# UNITED STATES PATENT AND TRADEMARK OFFICE

10/594,942

<b>Office Action Summary</b>	<b>Application No.</b> 10/594,942	<b>Applicant(s)</b> OMDOLL ET AL.	
	<b>Examiner</b> AZIM RAHIM	<b>Art Unit</b> 3744

## **DETAILED ACTION**

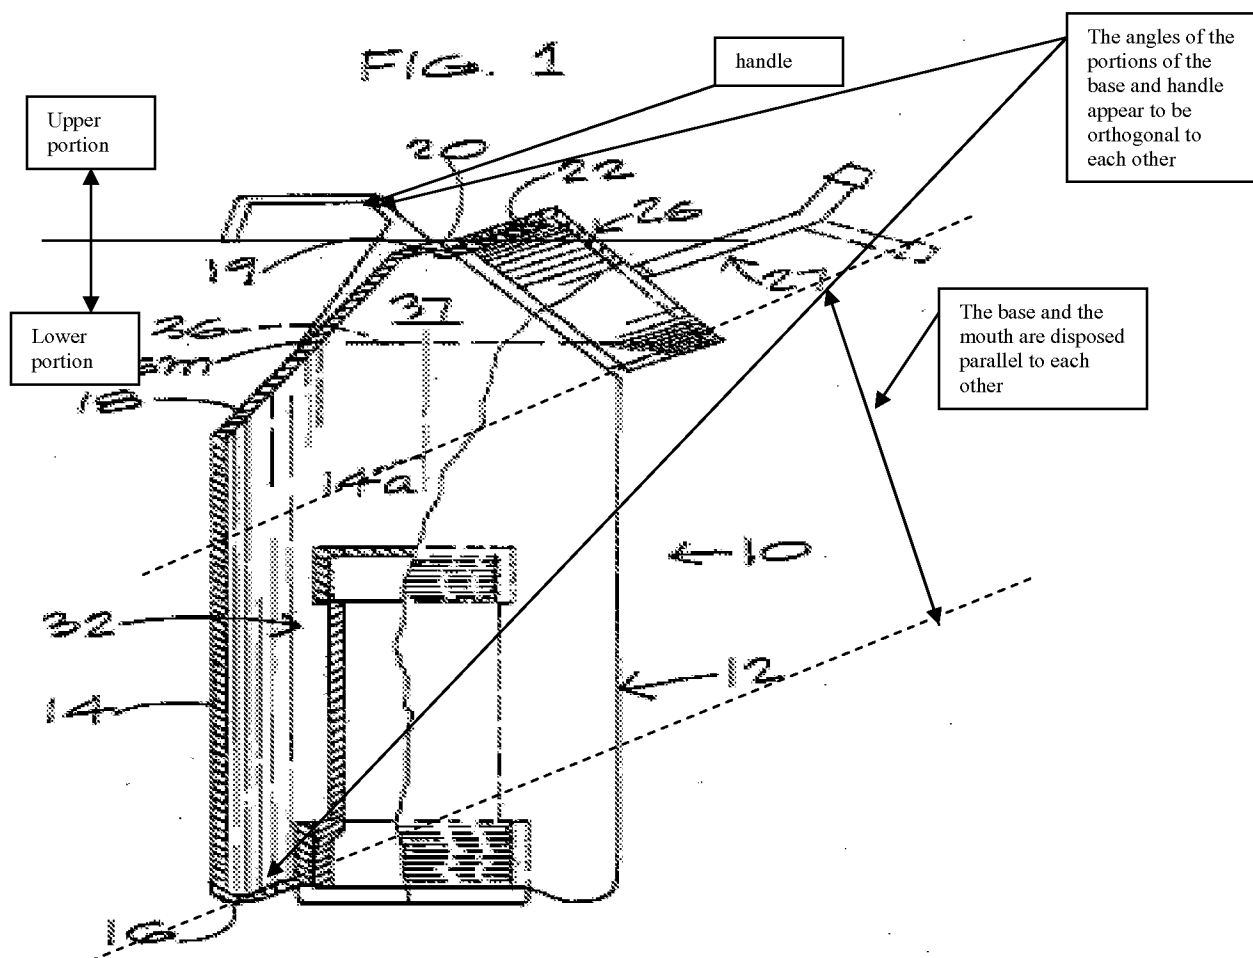
Regarding claims 1, 8 and 18, Vinarsky teaches a device [figure 1] for chilling a warm material in a vessel, comprising: a body (12) having a base (16), a series of sidewalls (14 and 32) extending upwardly from the base [illustrated in figure 1], a top (18) connected to the sidewalls and above the base [illustrated in figure 1], wherein the base, sidewalls, and top collectively

define at least a partially hollow interior [illustrated in figure 1]; a mouth [area disposed inside neck 22] situated on said body providing access to the hollow interior of said body [column 3, lines 39-41], wherein said mouth is formed in the top of said body [illustrated in figure 1] and has an opening defined along a plane that is parallel to the base [annotated in the drawing shown below]; wherein the mouth defines a maximum fill level (36) at which a cooling substance may be loaded into the body [illustrated in figure 1]; a cover (26) having a hollow interior [illustrated in figure 1] that is fluidly coupled to the hollow interior of the body when the cover is engaged with the mouth [illustrated in figure 1], such that when the hollow interior of said body is filled with liquid, the hollow interior of the cover remains unfilled with the liquid [the structure as taught by Vinarsky is capable of performing this intended use function] and to provide for expansion of liquid from within the body through the mouth and into the hollow area of the cover when said body is filled with a cooling substance and then frozen or otherwise exposed to an environment that causes the cooling substance with which said body is filled to expand liquid [the structure as taught by Vinarsky is capable of performing this intended use function]; wherein the cover and the body collectively provide a closed volume that permits limited expansion of liquid contained in the body into the cover [the structure as taught by Vinarsky is capable of performing this intended use function]. Vinarsky further teaches that the body has a lower section [annotated below] and an upper section [annotated below] and wherein the lower section includes a bottom surface (16) for supporting the device in a standing position when the device is placed in the vessel [this is an intended use limitation that recites function rather than structure and the body is capable of being placed inside of a vessel]; wherein the mouth is formed in the lower section of the body [illustrated below]; and a handle [annotated below] formed in the

upper section of the body [illustrated below], wherein the handle has a generally upright orientation defined orthogonal to the bottom surface of the lower section [annotated below].

Regarding claims 3 and 10, Vinarsky teaches that the mouth is sized to accommodate ice cubes [as illustrated in figure 1, the mouth is capable of accommodating ice cubes smaller than the mouth].

Regarding claims 6 and 13, Vinarsky teaches a means for hanging said device (annotated below).

Regarding claim 14, Vinarsky teaches that the means for hanging said device is part of said cover [illustrated in below, the handle is integrally connected to the cover when the cover is connected to the body].

Regarding claim 20, Vinarsky teaches that the mouth is defined along a plane that is parallel to that of the bottom surface of the lower section [annotated below].
